SUNDRY NOTICES AND REPORTS ON WELLS

MCA Unit 463

ConocoPhillips respectfully requests to do a 2-stage cement job on the MCA 463, running 5-1/2" production casing and cementing into place. Procedure and well schematic are attached.

CONDITIONS OF APPROVAL

Proposed

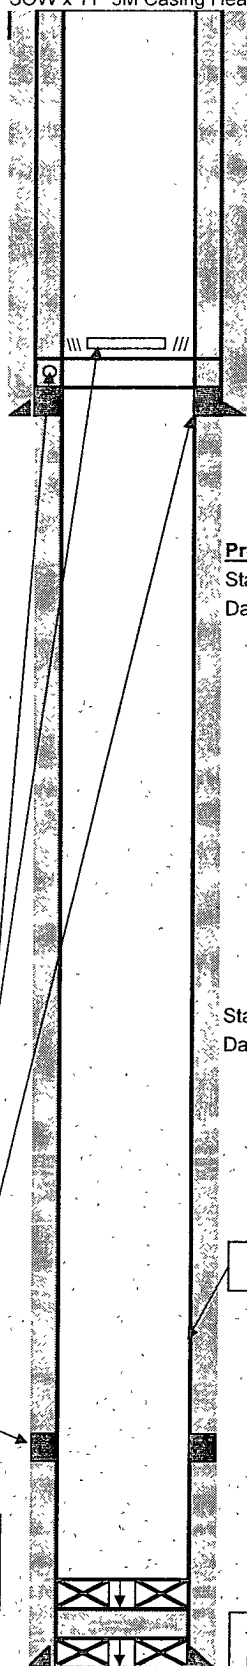
1. The minimum required fill of cement behind the 5 1/2 inch production casing is:

a. First stage to DV tool, cement shall:

☒ Cement to circulate. If cement does not circulate, contact the appropriate BLM office, before proceeding with second stage cement job.

b. Second stage above DV tool, cement shall:

☒ Cement to surface. If cement does not circulate, contact the appropriate BLM office.
